Technical Service Tip !

Baby Lock Unity, Crescendo, Spirit, Needle Threader Exchange Procedure:

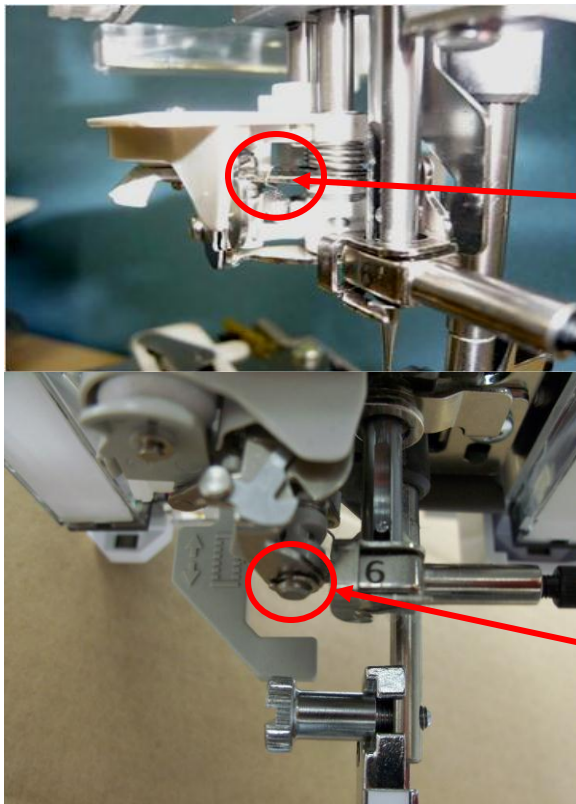
The new advanced needle threader hook that has been added to the BLTY, BLCR, and BLPY has a spring return spring similar to the BLSO. Failure to detach spring prior to removing the threader hook will cause damage to the spring.

There has also been a 'C' clip (part number 048025346) added under the threader hook to secure it in place.

You must remove the 'c' clip before attempting to remove the threading unit.

1. First detach spring from metal plate, with use of a small tool such as a crochet hook.

Remove c-clip from below threader
